Landscape and Visual Impact Assessment – Addendum

Varley Solar Farm

Date: May 2023 | Pegasus Ref: P22-0915EN

- 1.2. The Addendum has been prepared by Pegasus Group, who were the authors of the original LVIA. It serves to address comments made by the South Gloucestershire Council Landscape Officer in relation to the submitted LVIA.

Appendix 1: Updated Landscape Masterplan

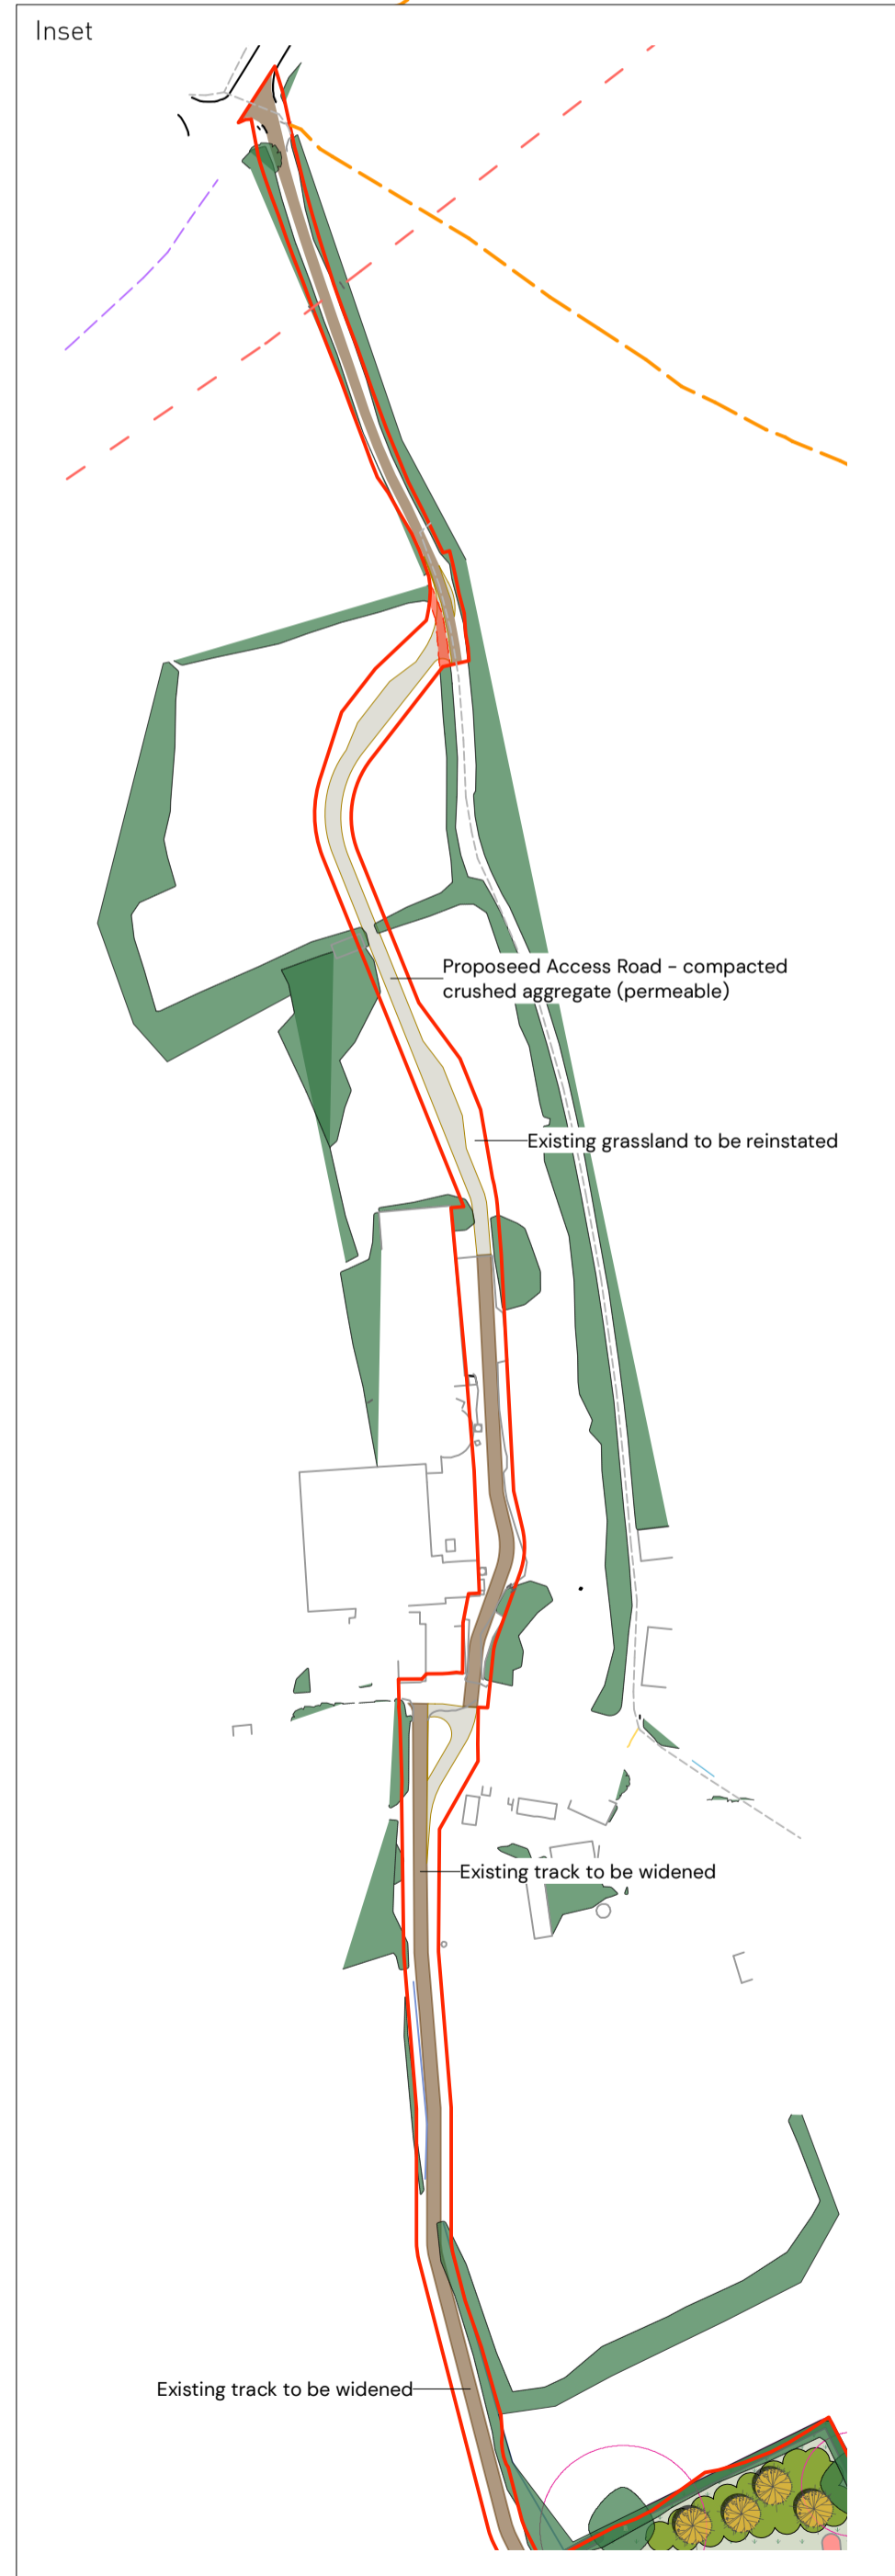
- 1.4. The Landscape Officer requested that additional tree planting be included as part of the landscape proposals, including to serve to help reduce visibility of the proposals from properties to the north and west of the site. RES were happy to accommodate that request (albeit noting that generally speaking solar developments seek to avoid planting new trees where they might lead to overshadowing that could compromise the efficiency of the development). An updated Landscape Masterplan is included at **Appendix 1** to this Addendum. This now includes additional proposed woodland at the northernmost extent of the site, as well as the addition of 58no. trees along the northern and western boundaries and along the public rights of way. It is considered that the addition of this planting will aid in further mitigating any views of the site, particularly to the residential receptors on Talbot's End.

- 9.5. As noted in Section 1, following comments made by the landscape officer, additional proposed woodland has been provided at the northernmost extent of the site as well as the addition of 58no. trees along the northern and western boundaries and along the public rights of way. It is considered that the addition of this planting will aid in further mitigating any views of the site, particularly to the residential receptors on Talbot's End. The maintenance and management of the proposed planting and boundary treatments will be secured via an appropriately worded condition. It is important to note that all landscape mitigation proposed will be in situ for the lifetime of the development and will remain as a feature of the landscape following the decommissioning of the scheme.

Appendix 2: Detailed Landscape Proposals

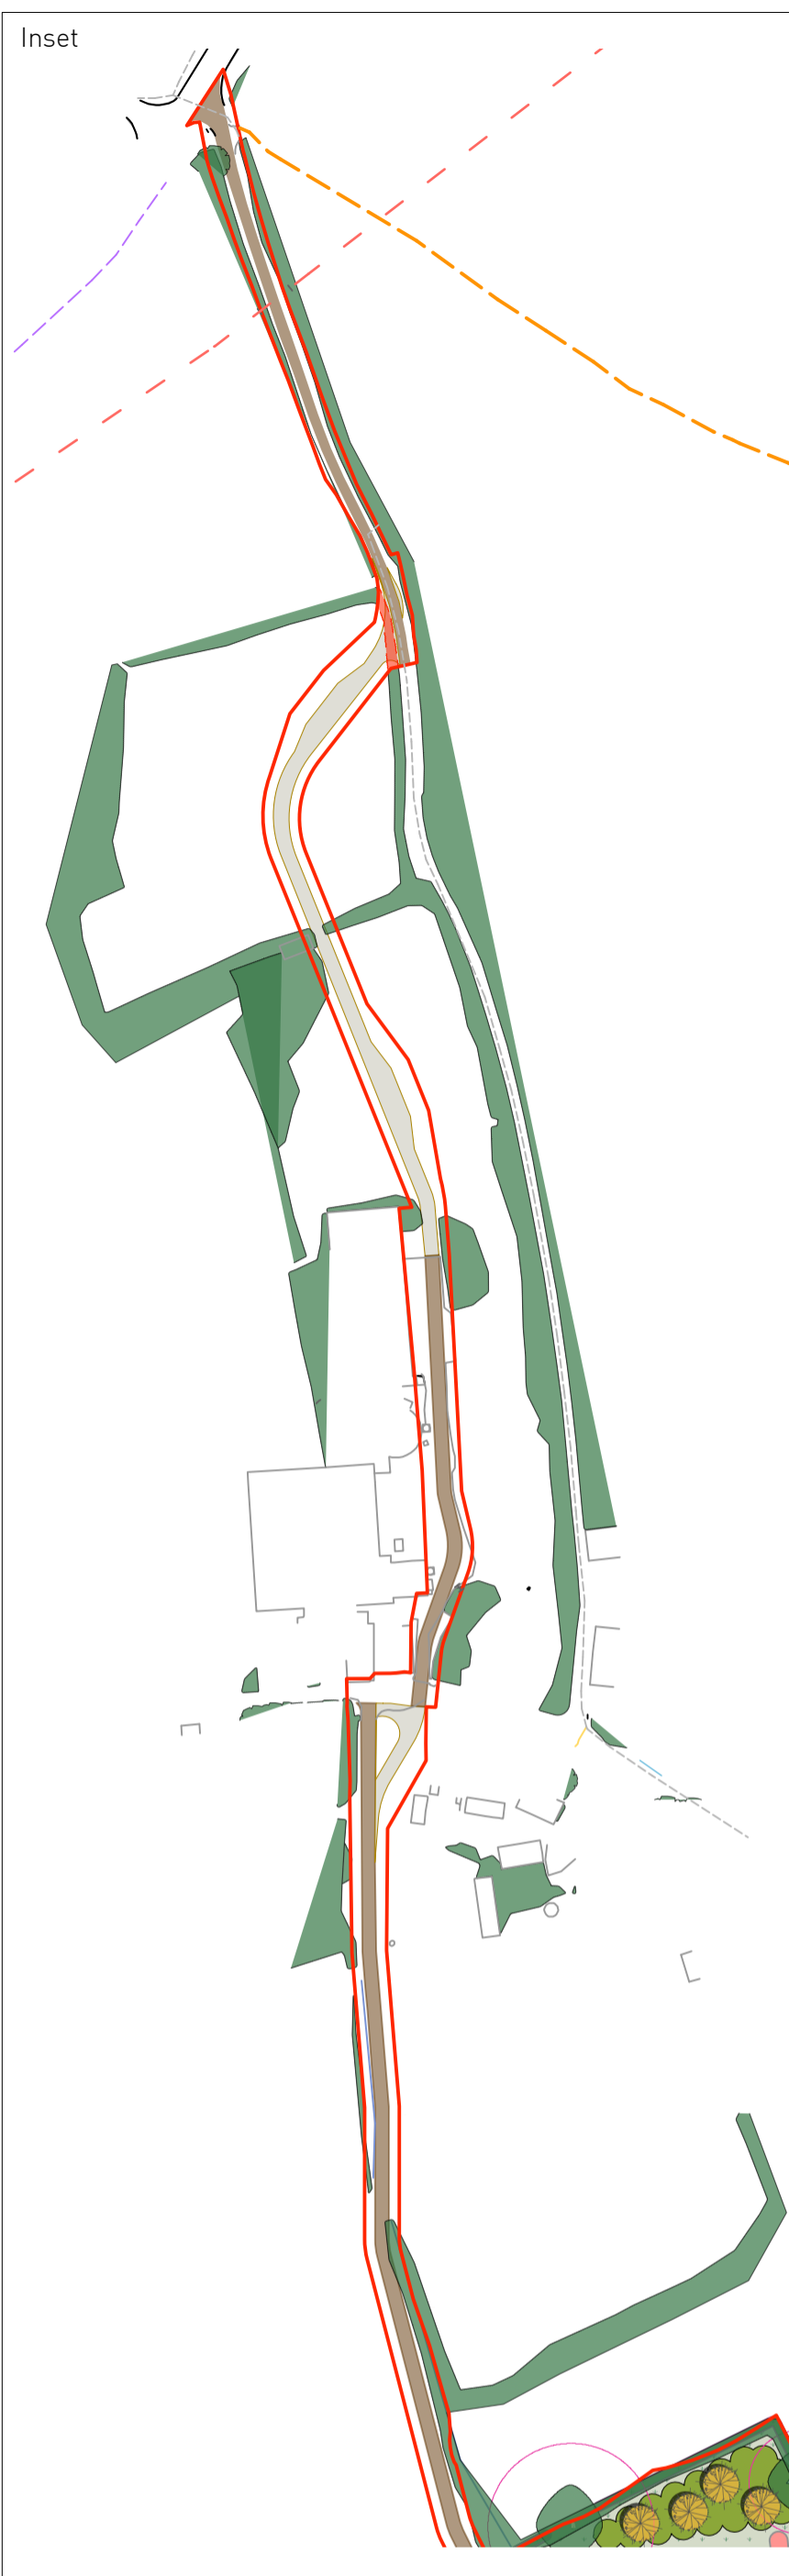
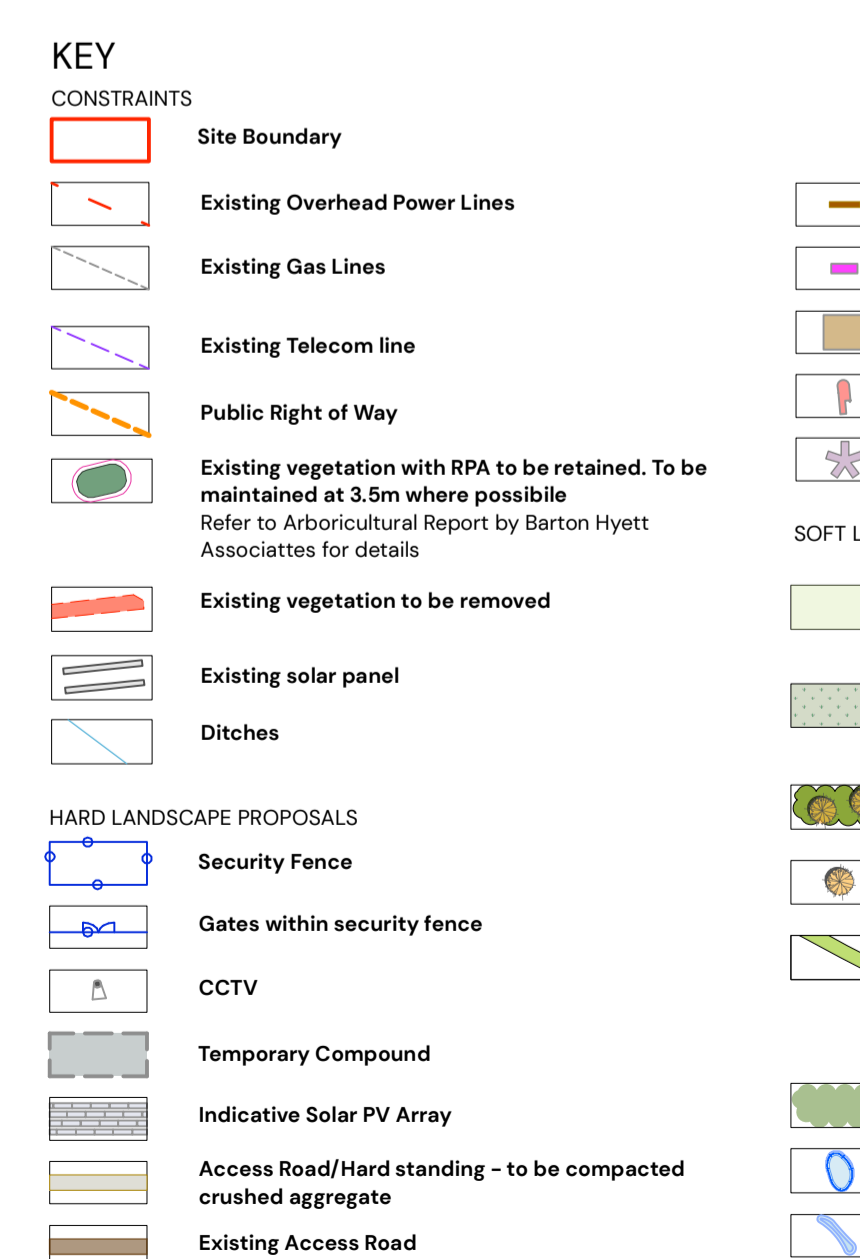
15. The Landscape Officer also requested a Detailed Landscape Proposals plan is provided. RES were also happy to accommodate that request and this plan is included at **Appendix 2** to this Addendum.

Appendix 3: Wireline overlays

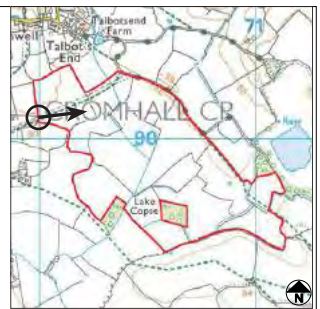
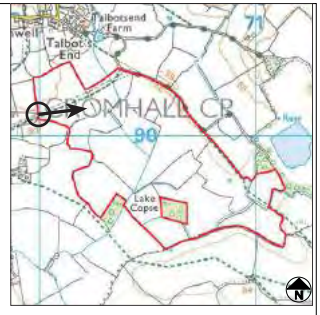
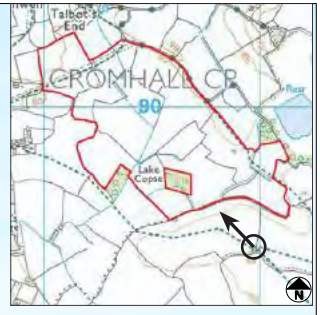
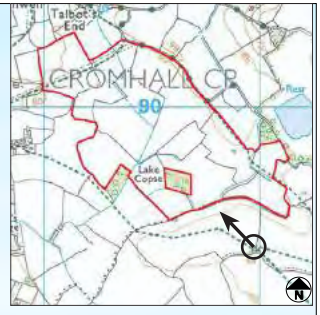
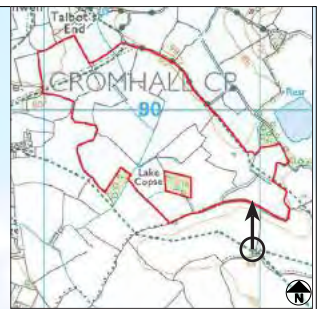
16. The submitted LVIA included wireline and photomontage visualisations from 3no. of the assessment viewpoints (VPs 2, 3 and 9). The Landscape Officer requested additional wireline overlays from 'VPs 3, 10 and 11 together with any other new views from B4058 corridor as discussed above'. RES were happy to accommodate the request for wireline overlays to be produced and have done so for VPs 2, 3, 9, 10 and 11, which are included at **Appendix 3** to this Addendum. It is not considered that any further locations for wireline overlay are necessary, nor would any further photomontages be required. It is also considered that none of the assessment judgements set out in the LVIA require amendment in light of the production of the wirelines which serve to confirm the findings previously set out.
